Watts Bar Nuclear Plant, Unit 1
Facility Operating License No. NPF-90
NRC Docket No. 50-390

Watts Bar Nuclear Plant, Unit 2
Facility Operating License No. NPF-96
NRC Docket No. 50-391

Subject: **Watts Bar Nuclear Plant Units 1 and 2 - Response to Request for Additional Information Regarding Request to Revise Technical Specifications for Diesel Generator Completion Time Extension for Technical Specification 3.8.1, AC Sources – Operating (TAC Nos. MF7147 AND MF7148)**

Response To Request for Additional Information Regarding Request to Revise Technical Specifications for Diesel Generator Completion Time Extension for Technical Specification 3.8.1, AC Sources – Operating (TAC Nos. MF7147 AND MF7148) for Watts Bar Nuclear Plant Units 1 and 2

Figure 1
Watts Bar Nuclear Plant Example
Station Blackout with FLEX Diesel Generators

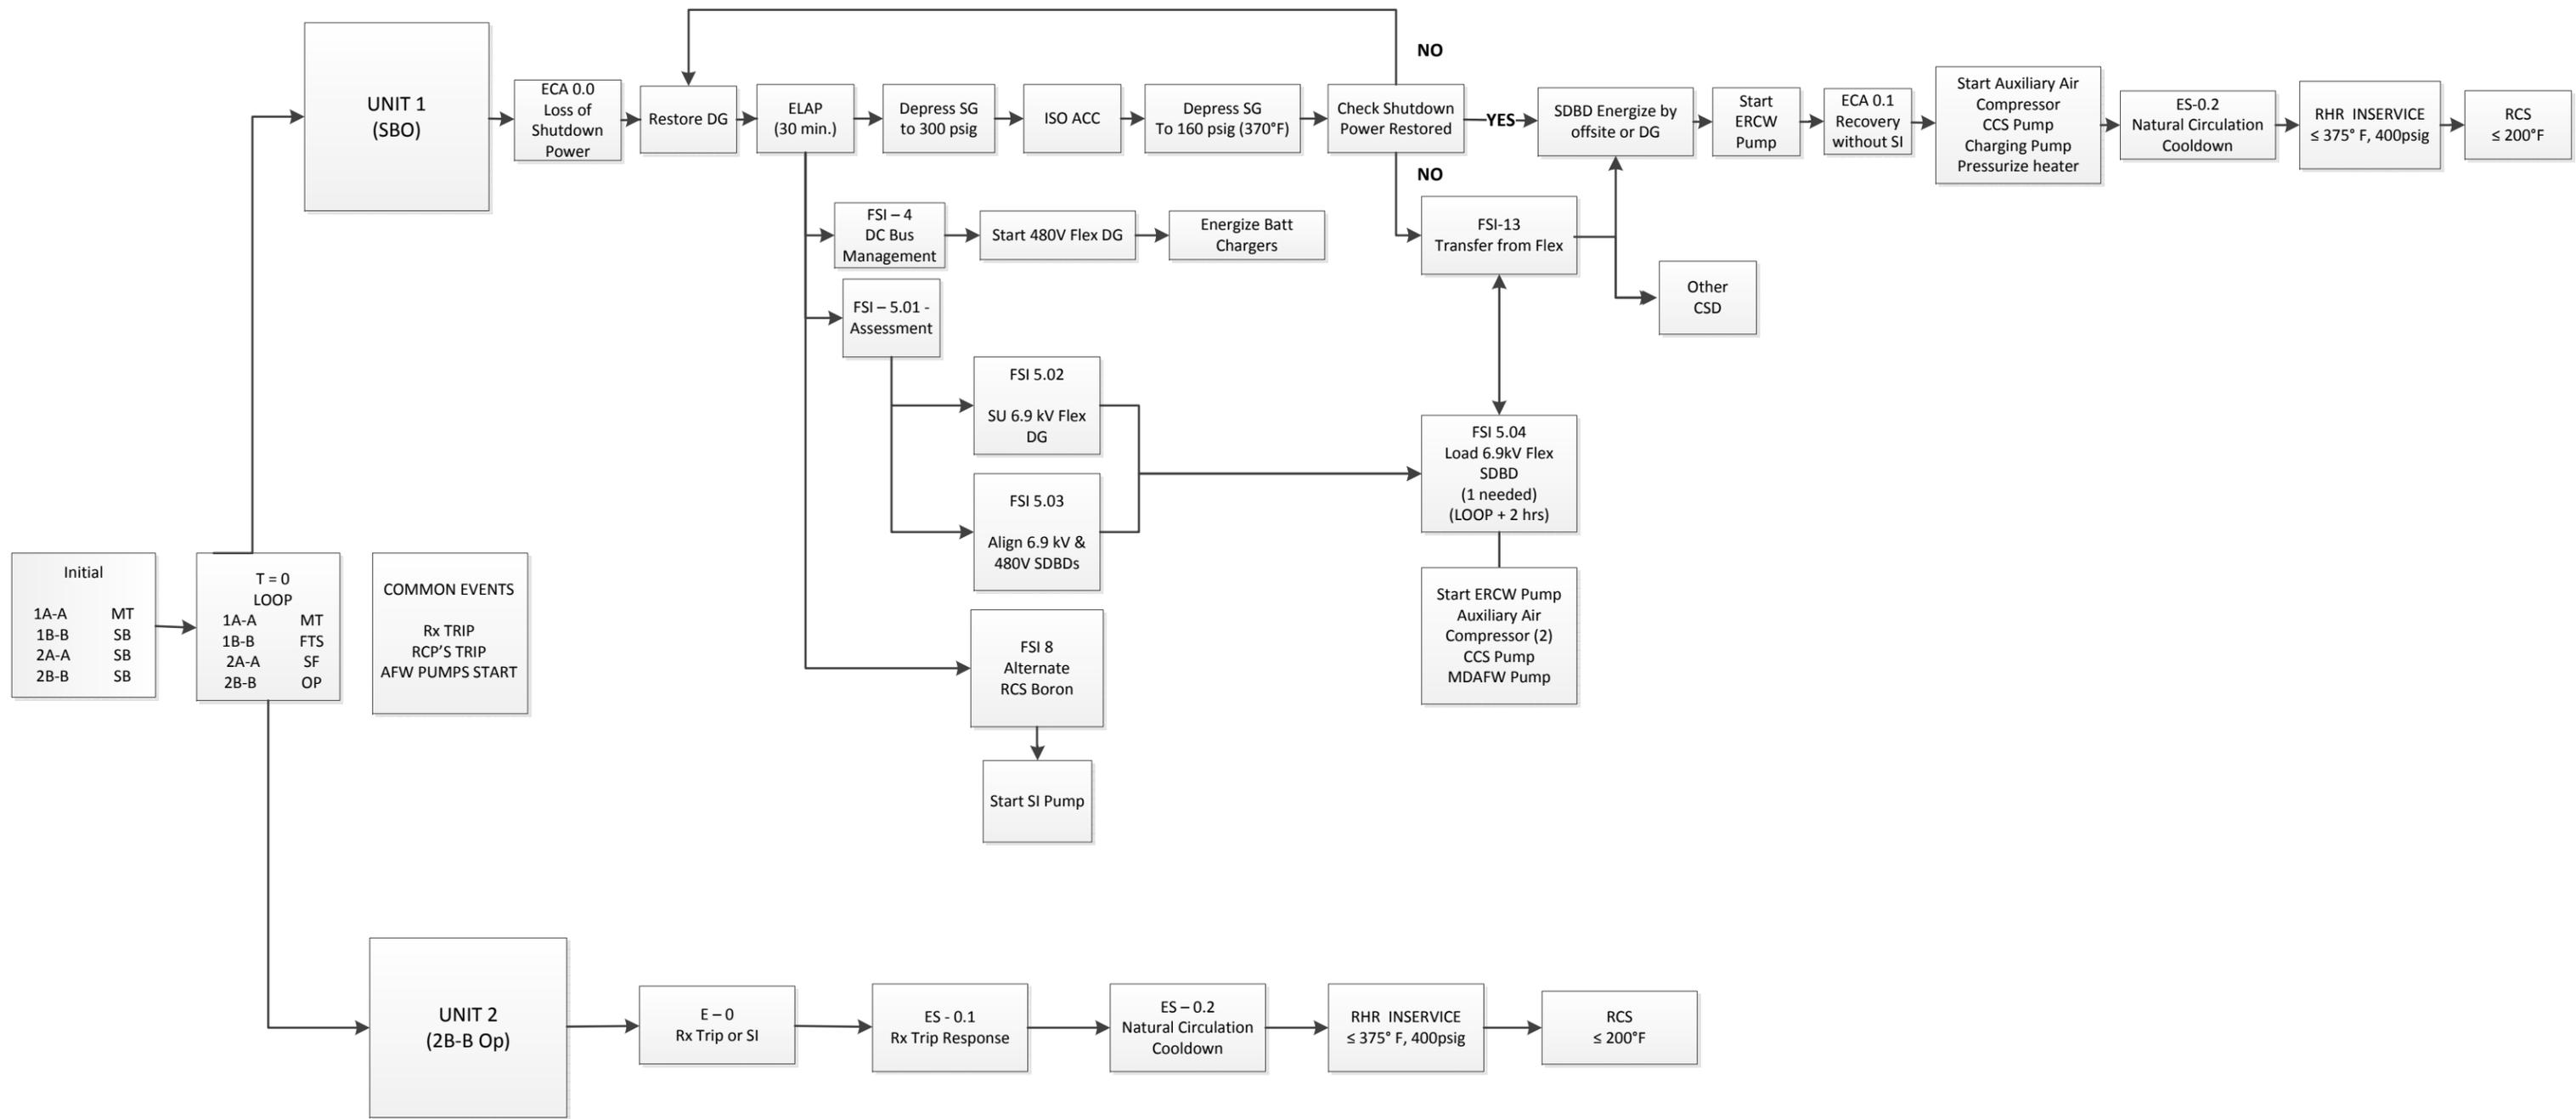
- a) Please explain the sequence of events of a LOOP (both Units) when Unit 1 DG 1A-A (or 1B-B) is under maintenance, the redundant DG 1B-B (or 1A-A) fails to start (SBO Unit 1) and a Unit 2 DG has a single failure.*
- b) Please explain if the response is also applicable for SBO in Unit 2 and single failure of a DG in Unit 1*
- c) According to the Watts Bar licensing basis, safe shutdown is considered as placing both units in a hot standby (Technical Specification MODE 3) condition and maintaining such a condition. However in view of proposed extended maintenance on one standby DG, BTP 8-8 recommends that the supplemental AC source, used to support extended CT, have the capacity and capability to bring the Unit to cold shutdown. Please confirm that one 6.9 kV FLEX DG coupled with one standby DG is adequate to place both units in cold shutdown and maintain cold shutdown conditions.”*

- a) In the event of a complete loss of offsite power (LOOP) (i.e., loss of 500 kiloVolt (kV) and 161 kV power supplies), both units would trip due to the load rejection. The loss of voltage to the 6.9 kV SDBs would initiate a turbine driven auxiliary feedwater (TDAFW) pump start on both units. Refer to Figure 1 for a flow path example of the activities the WBN staff would perform to bring the units to cold shutdown.

In the example shown in Figure 1, initially both units at WBN are at 100% power with DG 1A-A out-of-service for maintenance. The other DGs are operable and in a standby condition. As defined in NRC Request 3a, the event is initiated when a LOOP occurs; DG 1B-B fails to start, and DG 2A-A also fails to start as the single failure, leaving DG 2B-B as the only DG in operation. These failures result in WBN Unit 1 in a station blackout (SBO) condition with no offsite or onsite power available to the Unit 1 6.9 kV shutdown boards (SDBs) (1A-A and 1B-B). WBN Unit 2 DG 2B-B is powering 6.9 kV SDB 2B-B while the 2A-A 6.9 kV SDB is de-energized.

As stated in ECA-0.0, a recovery plan is needed after FLEX implementation is started to energize a shutdown board when a plant DG or offsite power has been made available. The flowpath outlined in Figure 1 would provide guidance on placing the unit in cold shutdown whether offsite power, DG power, or FLEX DG power is used.

Because this question results in WBN being in an SBO condition, Figure 1 and the response to NRC Request 3 can be referenced.

Figure 2

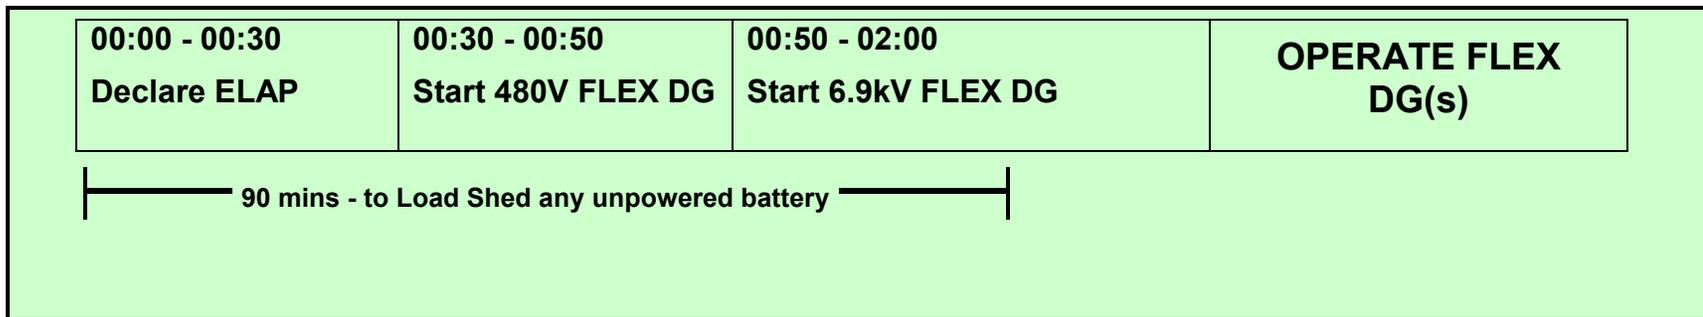
“Please provide details of DG loadings for the scenarios considered in question 5 above. In view of the differences in DG loadings, please indicate which case is the limiting case. Also, provide a time-line based on plant procedures, for connecting the proposed 6.9 kV FLEX DG to the associated safety-related bus/busses in the above scenarios.”

- a) Please confirm whether the 480 V FLEX DGs are part of the proposed extension request for DGs and will have the same requirements for testing and availability checks as the 6.9 kV FLEX DGs.*
- b) Assuming that it takes the proposed TS allowed time of 2 hours to establish the availability of the 6.9 kV FLEX DG, please provide a time line, using current plant procedures, for connecting the proposed 6.9 kV FLEX DG and the 480 V FLEX DG (if required) to each of the associated safety busses if an unplanned DG maintenance was being conducted and a LOOP event is experienced.*
- c) For the event postulated in item b) above, please confirm if the Unit with DG undergoing maintenance will first enter SBO procedures if the associated DG fails to start.”*

The loading for the FLEX DGs, as shown in Table 3-1 would be approximately the same for all alignments with exception of the alignment to the 6.9 kV SDB 1B-B because it would not have a CCS pump connected. In this case, the loading would be 265 kW less. The timeline, based on plant procedures, for connecting the proposed 6.9 kV FLEX DG to the associated safety-related busses is shown on Figure 2, approximately 2 hours.

- b) Figure 2 contains a pictorial display of the timeline. ECA-0.0 states that if power is not restored to a 6.9 kV SDB within 30 minutes an ELAP is declared and FSI-4 and FSI-5.01 are entered to manage the DC distribution system and FLEX strategies. FSI-4 starts the 480 V FLEX DG or, if they are not available, provides guidance on shedding loads on the batteries and alignment to the 6.9 kV FLEX DG. Estimated time for energizing the 6.9 kV SDB(s) with a 6.9 kV FLEX DG is 2 hours. Further information is provided in the response to NRC Request 3a.
